53 MW on OML 30 associated gas: what the satellite record says

A technical review of a flare-to-compute project in Delta State, Nigeria

Igor Shibanov, K4-Technology · 14 August 2026

Figure 2. VIIRS-estimated flare gas volume at the three sites, 2020–2024. The shaded band is the gas required for 53 MW of installed nameplate when net output equals 40–50% of nameplate (a 50–60% reduction).

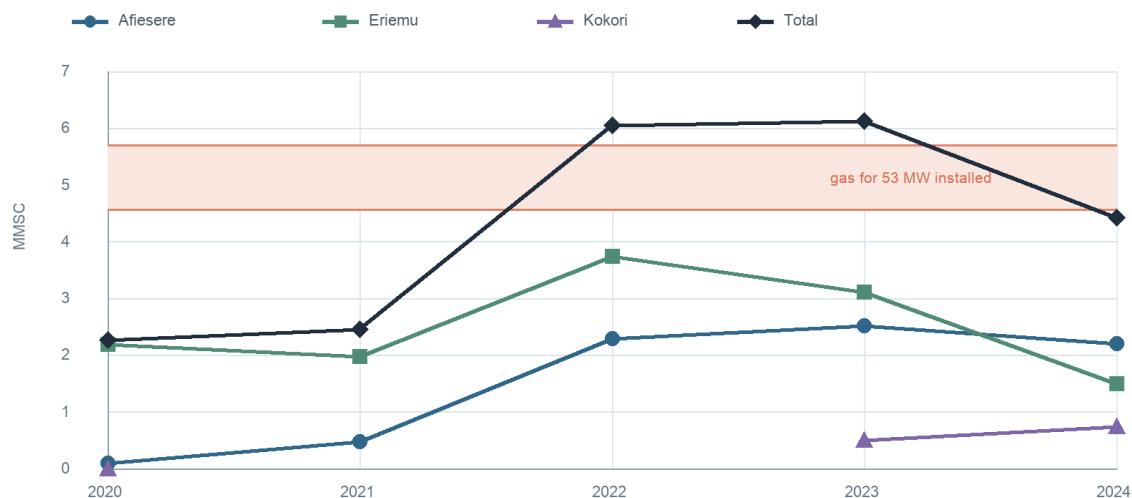
The 2024 VIIRS estimate is 4.42 MMSCFD. It lies near the lower edge of the scenario band, but this coincidence does not confirm the output factor used in the project's design.

Coverage check by year: if net output equals 40-50% of nameplate, 53 MW installed requires 4.56-5.70 MMSCFD. The VIIRS estimate covers this band in 2022 and 2023; 2024 is near the lower edge. Coverage in 2020-2021 would have been about 40-50%. This is a screening result and requires operator data.

Figure 3. Detection frequency in 2024: the share of cloud-free satellite observations in which a burning flare was detected.

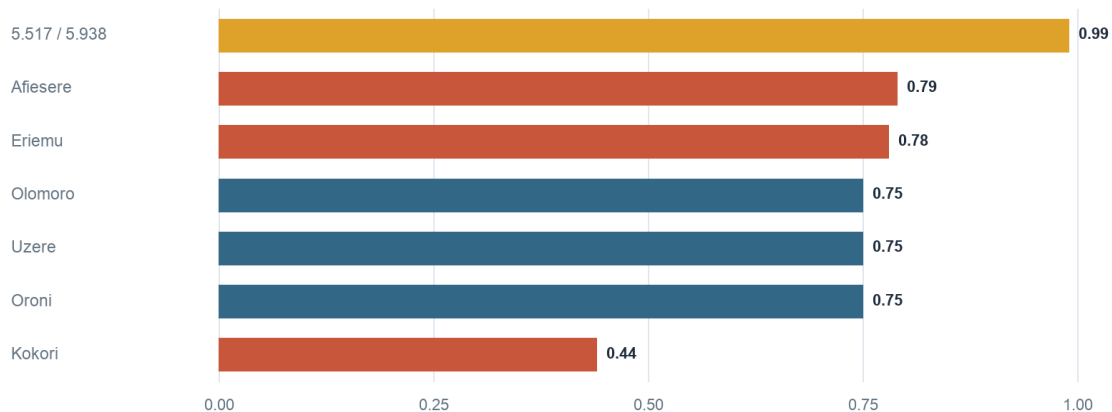
Kokori. No matching flare was detected in the annual summaries before 2023. Frequencies of 0.27 in 2023 and 0.44 in 2024 mean that a burning flare was detected in those shares of cloud-free observations; they are not direct duty-cycle measurements. Combined with the 1.45 km match distance, this makes Kokori the most uncertain of the three sites.

Figure 4. Calculated methane number as a function of gas specific gravity. Points A, B and C are the composition scenarios from Section 6.

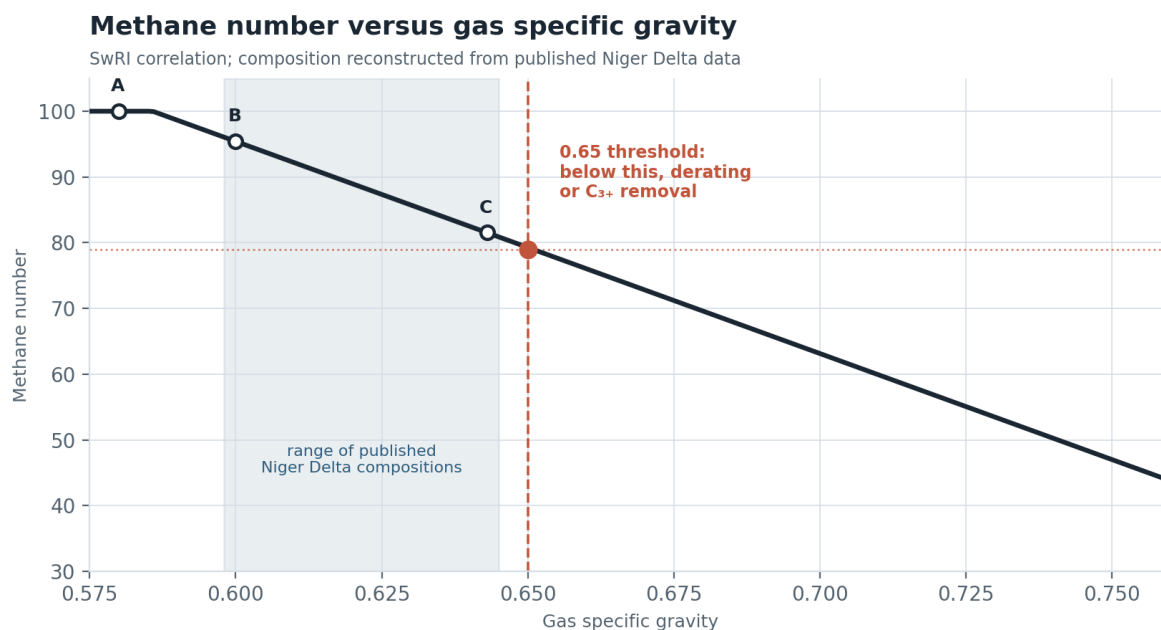
Specific gravity around 0.65 is used here as a screening marker. Acceptable methane number and the need for C₃₊ removal depend on the selected engine, boost, ignition strategy and OEM fuel limits [5, 9].

If flare-gas specific gravity is around 0.63-0.65, some standard lean-burn solutions may be suitable; closer to 0.70, C₃₊ removal or a different engine selection may be required. The stated 30-100% fuel-treatment uplift is only an author screening range. FID requires a chromatogram, process design and vendor quotations.

Specific gravity and full composition can be established by representative sampling with laboratory gas chromatography or by an online chromatograph. Until those data exist, engine and fuel-treatment selection remains conditional.
